Contract #: 04-0120F4
 Cty: SF/ALA Rte: 80 PM: 13.2/13.9
 File #: 69.25B

QUALITY ASSURANCE -- NON-CONFORMANCE REPORT

Reference Description: Missed MT Transverse Indication by QC on Segment 9EE Floor Beam Flange to Deck Diaphragm Weld

Job Name: SAS Superstructure
Document No: 05.03.06-000675

Report No: NCR-000718

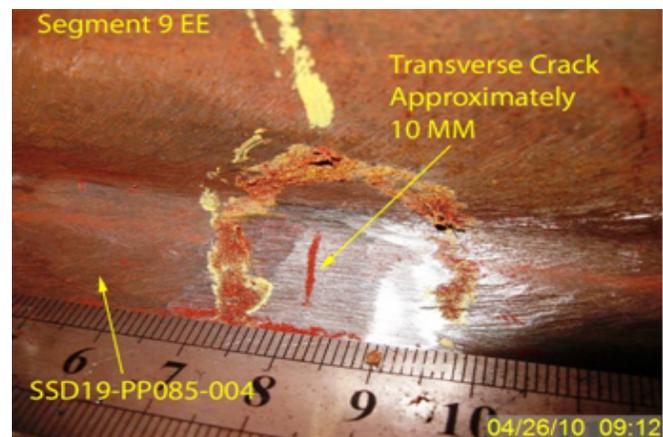
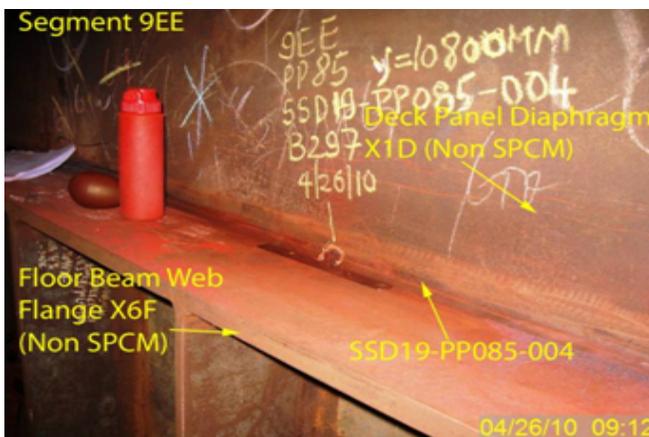
- One (1) transverse crack measuring approximately 10mm in length in the fillet weld joining the Deck Panel Diaphragm (X1D) to Floor Beam Web Flange (X6F) at panel point 85.
- The Y location is 10800mm from the termination of the weld on the crossbeam side.
- The indication is clearly marked near the weld.
- The weld is identified as: SSD19-PP085-004.
- OBG segment 9EE is located north of the blast shop.
- The Notice of Witness Inspection Number (NWIT) is 005583. The indication is located within the area that has been previously tested and accepted by ZPMC Quality Control (QC) personnel.

ZPMC has repaired the welds in question and is providing NDT documentation to show that the welds are acceptable. Based on this ZPMC requests closure of this NCR.

This proposed resolution is acceptable. The documentation received is sufficient and the Department concurs that Non-Conformance ZPMC-0685 is closed.

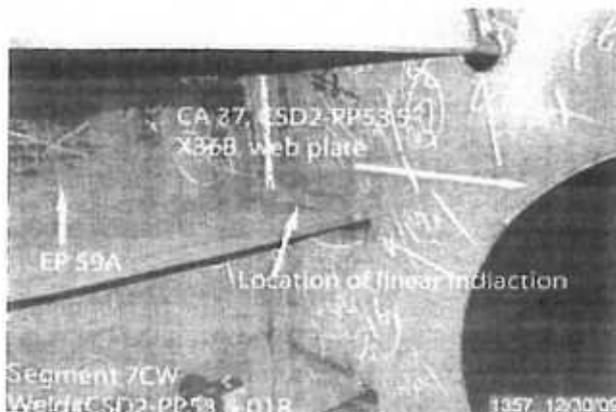
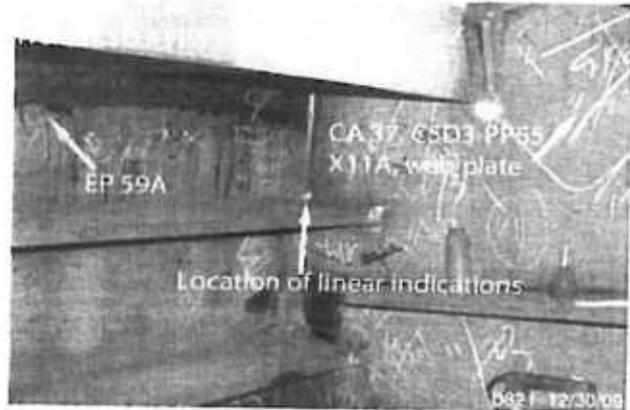
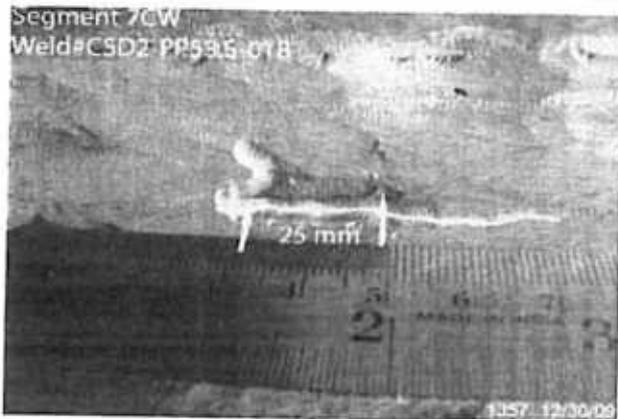
- Two (2) Longitudinal linear indication measuring approximately 20mm and 25mm in length.
- The welds are identified as: CSD3-PP55-025, 026 (30 mm) and CSD2-PP53.5-018 (25 mm).
- The welds are a Fillet Weld type joining the Edge Plate (EP59A) stiffeners to Corner Assembly (CA37A) web plates.
- The OBG 7CW segment is located at in front of Blast Shop.

The Notice of Witness Inspection Number (NWIT) is 004947. The indication is located inside the area that has been previously tested and accepted by ZPMC Quality Control (QC) personnel. ZPMC's QC personnel are required to perform twenty five (25%) percent MT inspection of this weld.

Submit a repair procedure to the engineer for approval. Provide the ZPMC MT technician additional training and equipment to ensure these types of indications are identified in the future.

Report No: NCR-000709

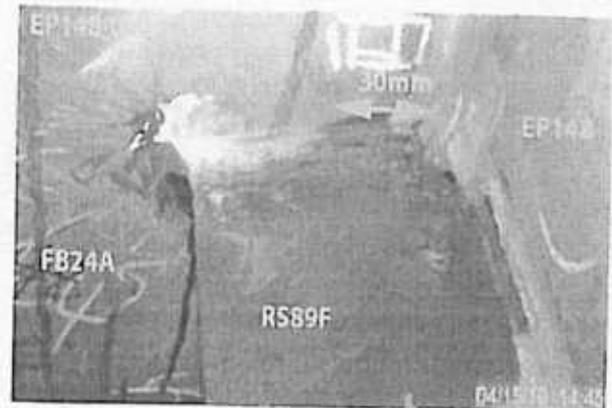
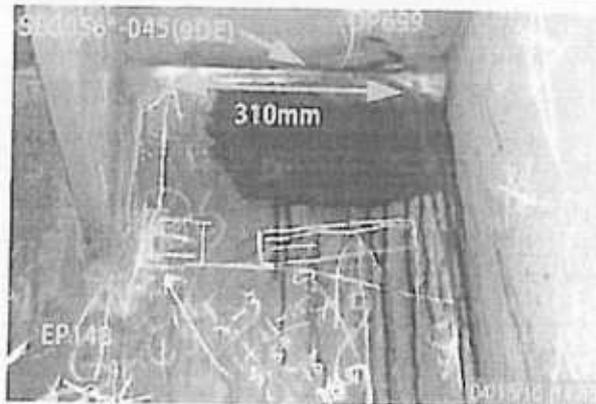
- Two (2) longitudinal linear indications measuring approximately 310mm and 30mm in length.
- The indications dBs rating are +6 and +4.
- Material thickness is 18mm.
- The depth of the indications is approximately 11mm and 13mm.
- The welds are identified as SEG056*-045 at Panel Point (PP) PP81.5 and EP148-022 at PP 81.
- The welds are designated as Seismic Performance Critical Material (SPCM).
- The indications are clearly marked on or near the weld.
- The Y distance for the indications are 50 mm from PP81.5 and 0 mm from EP148A.
- Weld SEG056*-045 is a Complete Joint Penetration (CJP) Corner joint, joining the Edge Plate PL1336C (SPCM) to Deck Plate PL1314A (Non SPCM).
- Weld EP148-022 is a Complete Joint Penetration (CJP) "T" joint, joining the Edge Plate stiffener RS89F (Non SPCM) to FB24A plate PLX24D (SPCM).
- Segment 9DE is located outside of Paint shop.

The Notice of Witness Inspection (NWIT) No. is 005523. The indication is located in an area previously tested and accepted by ZPMC Quality Control (QC) personnel. As per the contract documents, ZPMC's QC personnel are required to perform hundred (100%) percent UT inspection of this weld.

AWS D1.5-02 Section 6; Table 6.3 specifies a class "A" indication as having a rating of 10dBs and under for material thicknesses 8mm through 20mm.

Report No: NCR-000717

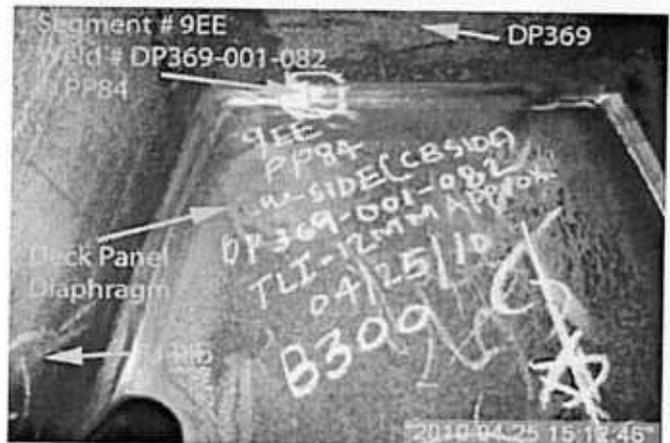
-One (1) Transverse linear indication measuring approximately 10 mm in length.

-Weld is a Complete Joint Penetration (CJP) Weld joining the Deck panel Diaphragm to U-Rib.

-Weld Identification number is DP477-001-137 @ Panel Point-083.

-Location Panel Point (PP83).

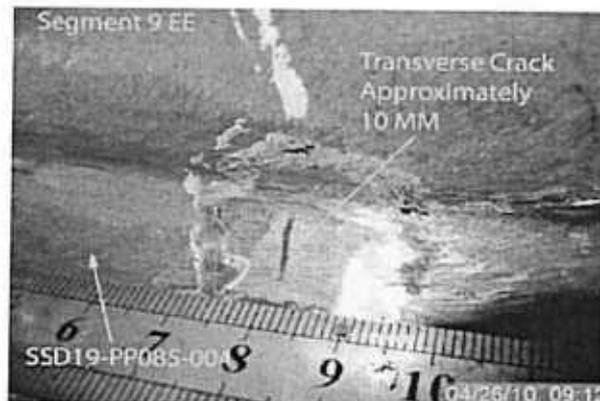
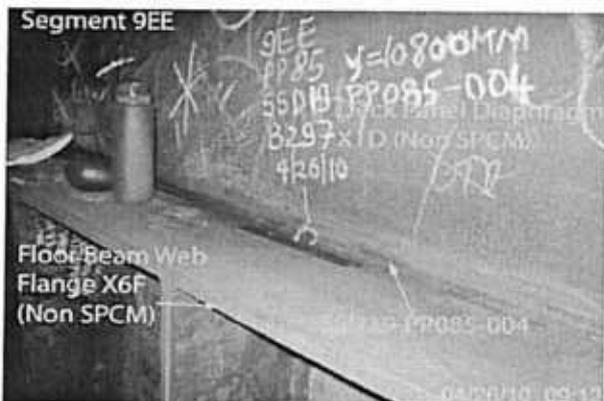
- One (1) transverse crack measuring approximately 10mm in length in the fillet weld joining the Deck Panel Diaphragm (X1D) to Floor Beam Web Flange (X6F) at panel point 85.
- The Y location is 10800mm from the termination of the weld on the crossbeam side.
- The indication is clearly marked near the weld.
- The weld is identified as: SSD19-PP085-004.
- OBG segment 9EE is located north of the blast shop.
- The Notice of Witness Inspection Number (NWIT) is 005583. The indication is located within the area that has been previously tested and accepted by ZPMC Quality Control (QC) personnel.

Report No: NCR-000723

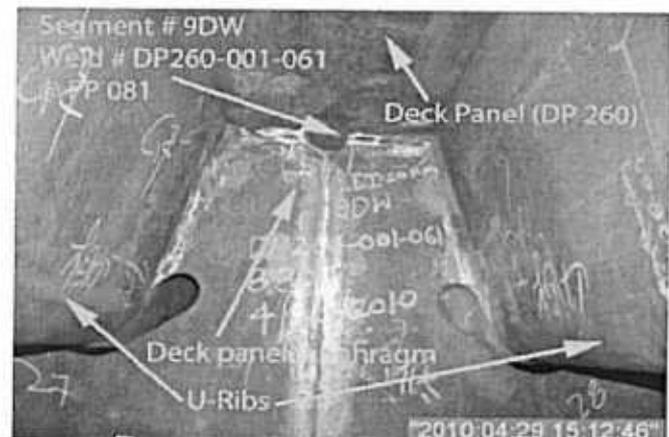
- One (1) Longitudinal linear crack like indication measuring approximately 20 mm in length.
- The weld is identified as DP260-001-061 @ Panel Point 081.
- The weld is a Fillet Weld T-joint joining the Deck Plate to Deck Panel Diaphragm plate.
- The plate number for Deck Plate is identified as PL307A (Non SPCM).
- Deck panel diaphragm plate is identified as X1E (Non SPCM).
- The indication is clearly marked on the material near the weld.
- OBG Segment 9DW is located at the back side of OBG Bay #14.
- The Notice of Witness Inspection Number (NWIT) is 005616. The indication is located inside the area that has been previously tested and accepted by ZPMC Quality Control (QC) personnel. Per the contract documents ZPMC's QC personnel are required to perform 100% MT inspection of this weld.

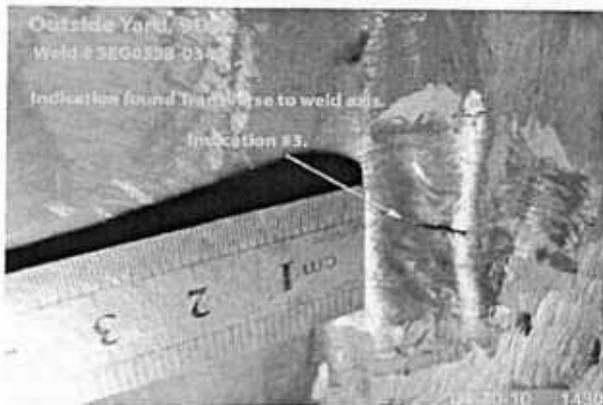
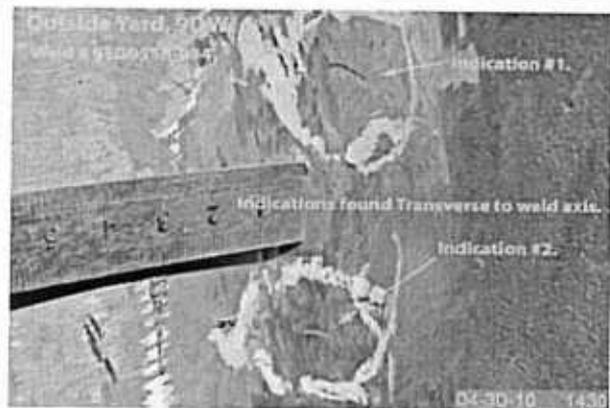
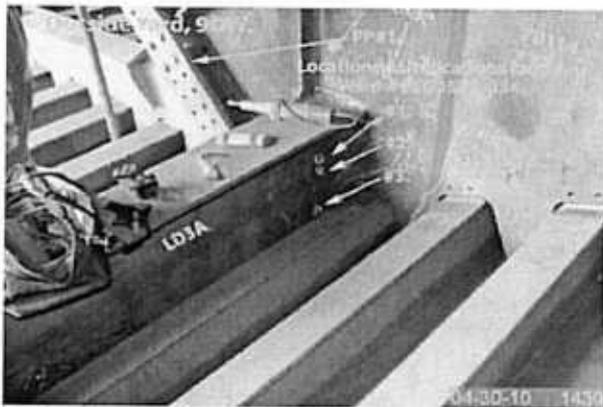
- Three transverse linear indications, one measuring approximately 9mm and two indications measuring approximately 5mm in length at Longitudinal Diaphragm (LD) LD3A to Floor beam (FB) FB11A.
- Weld is identified as SEG055B-034 and designated as a Fracture Critical Weld (FCW).
- The weld is a 14mm Complete Joint Penetration (CJP) T-joint joining LD 3A shear plate identified as X39B to FB web plate identified as X47C (Seismic Performance Critical Material SPCM).
- The indications are clearly marked on the material.

- One (1) Longitudinal linear indication measuring approximately 18mm in length.
- The Y location is 7mm from the cope hole.
- The indication is clearly marked on the material near the weld.
- The weld is identified as: CSD9-PP81-062.
- The weld is designated as Seismic Performance Critical Member (SPCM).
- The weld is located at PP81 (Counter Weight Side).
- The weld is a Fillet Weld T-joint joining the Corner Assembly Diaphragm identified as X11B (SPCM) to Side Plate identified as SP658 (SPCM).
- OBG segment 9DW is located west of Bay #14.
